Re: Initial Submission Review – Murphy Creek / Harvest Ridge PA Site Plan and Plat
Application Number: **DA-1250-54**
Case Numbers: **1995-2002-10; 2021-4019-00; 2021-3039-00**

First Submission Review

Figure 4.2-3: Motor Courts

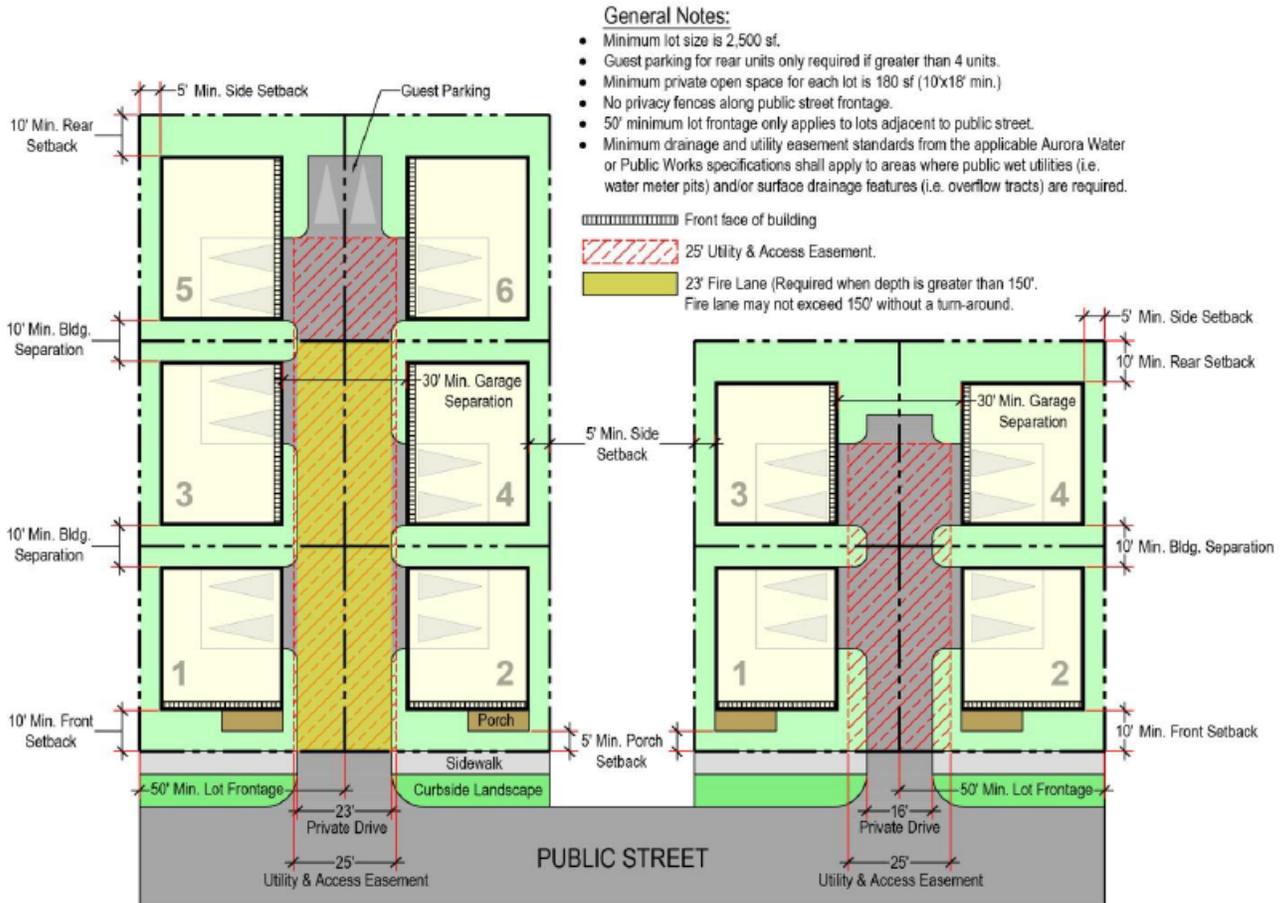
- 3I. As per the U.D.O. section 4.3.2.E, each Motor Court Dwelling development containing five or six dwellings shall include at least two guest parking spaces. Please include the guest parking in the next submittal
- 3J. The lot lines should be split down the middle of the internal "drive" for Motor Court Products.
- 3K. A very helpful chart is located below with Green Court setbacks and many standards.
- 3L. Can't have duplication of the motor court elevation for 1 and every 4 as well as diagonal or across the street.
- 3M. Please include a typical dimension. All garage needs to be 30' away garage face to garage face for motor court products.
